**PLANNED UNIT DEVELOPMENT
& SUBDIVISION STAFF REPORT****Date: June 15, 2006**

DEVELOPMENT NAME Providence Park, P.O.B. West Subdivision,
Resubdivision of

CONTEMPLATED USE 3-lot commercial subdivision, and Planned Unit
Development Approval to allow shared access and parking between multiple building
sites.

SITE PLAN

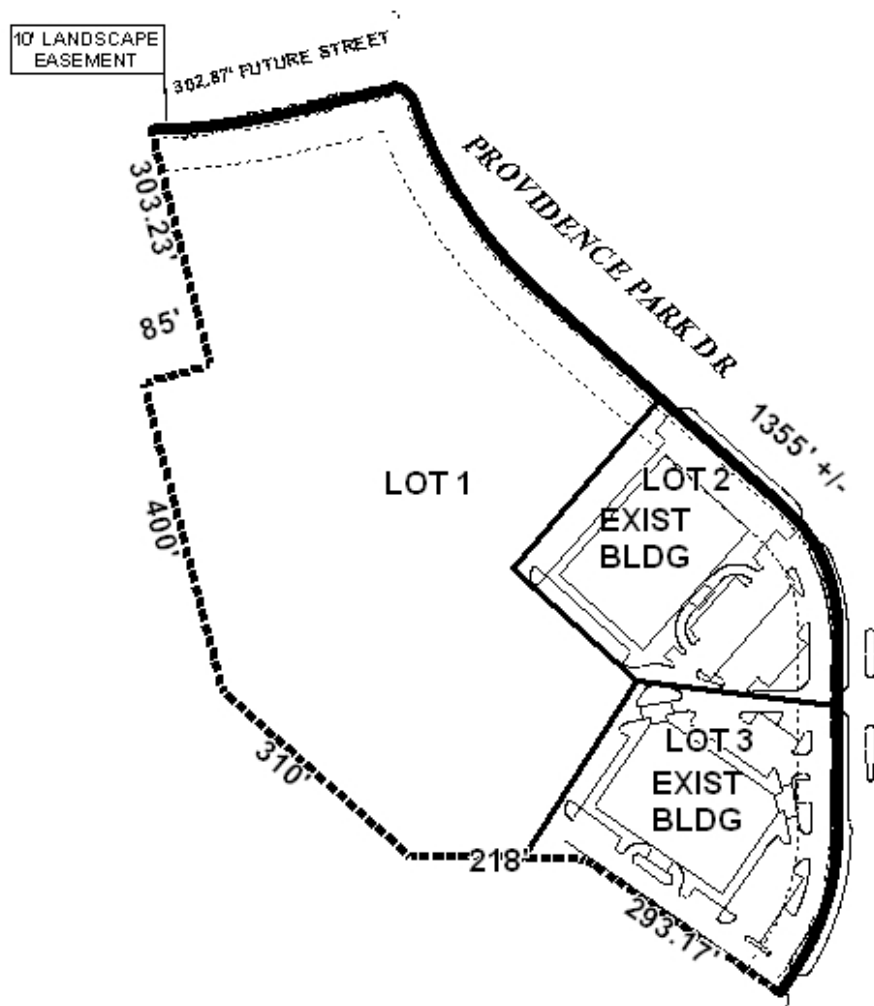
It appears that the new lot lines within the proposed subdivision will result in some existing surface parking being located on the proposed Lot 1, which is primarily undeveloped. The PUD application does not appear to include the proposed Lot 1, thus the preliminary plat or the site plan should be revised to either fully include the existing parking in proposed Lots 2 and 3, or the PUD application to include the proposed Lot 1 for shared access and parking across multiple building sites. It should also be noted that

the line dividing Lots 2 and 3 appears to be drawn differently between the PUD site plan and the Subdivision plat.

The original approvals also expressed concern regarding the number of curb-cuts proposed by the development. Access management is still a concern, therefore, it is recommended that proposed Lots 2 and 3 be limited to their existing curb-cuts, and that Lot 1 be limited to one new curb-cut onto Providence Park Drive and one curb-cut onto the proposed future street on the North side of the lot. The size, design and location of all curb-cuts must be approved by Traffic Engineering and conform to AASHTO standards.

RECOMMENDATION: **Planned Unit Development:** Based on the preceding, the PUD application is recommended for Approval, subject to the following conditions: 1) revision of the site plan and plat to fully include the existing parking within the proposed Lots 2 and 3, or revision of the PUD proposal to include the proposed Lot 1, as well as revision of the lot line dividing Lots 2 and 3 to be the same on the site plan and plat; 2) completion of the Subdivision process; 3) placement of a note on the site plan and final plat stating that Lots 2 and 3 are limited to their existing curb-cuts, and that Lot 1 is limited to one new curb-cut onto Providence Park Drive and one curb-cut onto the proposed future street on the North side of the lot, with the size, design and location of all curb-cuts to be approved by Traffic Engineering and conform to AASHTO standards; and 4) full compliance with all other municipal codes and ordinances.

Subdivision: Based on the preceding, the plat is recommended for Approval, subject to the following conditions: 1) revision of the site plan and plat to fully include the existing parking within the proposed Lots 2 and 3, or revision of the PUD proposal to include the proposed Lot 1, as well as revision of the lot line dividing Lots 2 and 3 to be the same on the site plan and plat; 2) placement of a note on the site plan and final plat stating that Lots 2 and 3 are limited to their existing curb-cuts, and that Lot 1 is limited to one new curb-cut onto Providence Park Drive and one curb-cut onto the proposed future street on the North side of the lot, with the size, design and location of all curb-cuts to be approved by Traffic Engineering and conform to AASHTO standards; and 3) full compliance with all other municipal codes and ordinances.
